**DTB**

Date: February 6, 2009  
Order No.: P-B-82.85/678  
Supersedes:  
Group: 82

**SUBJECT: Model 211.022/056/072/077/087/090/277/287, Model Year 2009  
Model 219.372/377, Model Year 2009  
No Audio or Low Volume/Bass from Right-Side Speaker Group When Using Auxiliary  
Audio Device - Aux**

Figure 2  
Correct (new) pin assignment

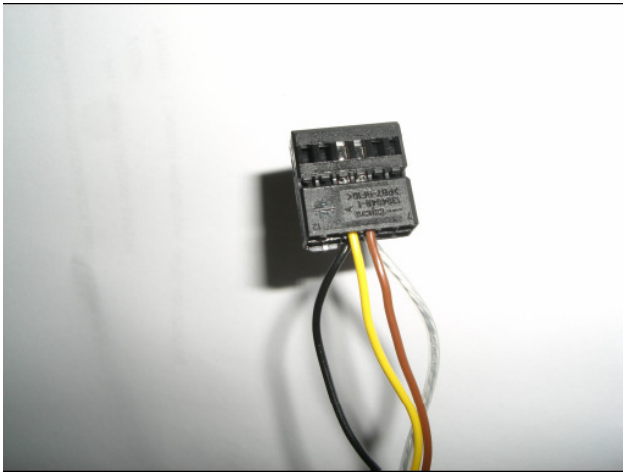
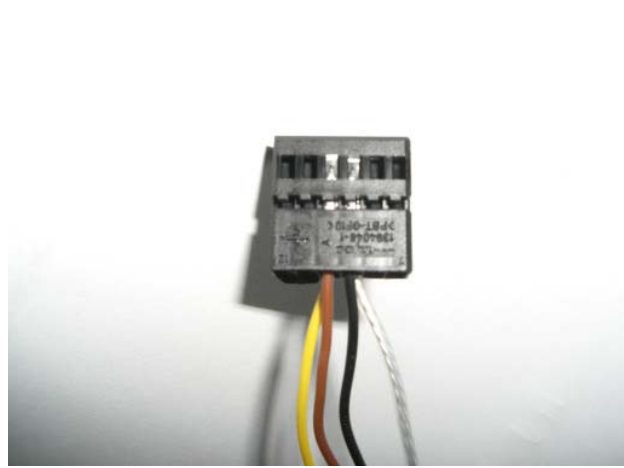
If you receive customer reports in the above model vehicles of the Auxiliary (Aux) Audio Device having no audio, volume too low/weak or low bass sound all from the right side speaker group, this may be caused by incorrect factory installation of the wiring harness connecting the head unit and the Aux Jack located in the glove box. To remedy, inspect the pinout assignments of the Head Unit Aux connector (JC) and if necessary, change the pin-out assignment (Figure1) in the connector housing on the head unit as described below in the pin assignment table and Figure 2.

**i** **Note:** The only pins that change assignment are: 4, 9 and 10. Pin 3 remains unchanged and the rest of the pinouts are unused.

**Pin Assignment Table**

| <b>Old pinout/Color</b> | <b>Function</b> | <b>NEW Pinout</b> |
| 3 / Clear               | Shield          | UNCHANGED         |
| 4 / Black               | Aux 1 Left      | To PIN 9          |
| 9 / Brown               | Ground          | To PIN 10         |
| 10 / Yellow             | Aux 1 RIGHT     | To PIN 4          |
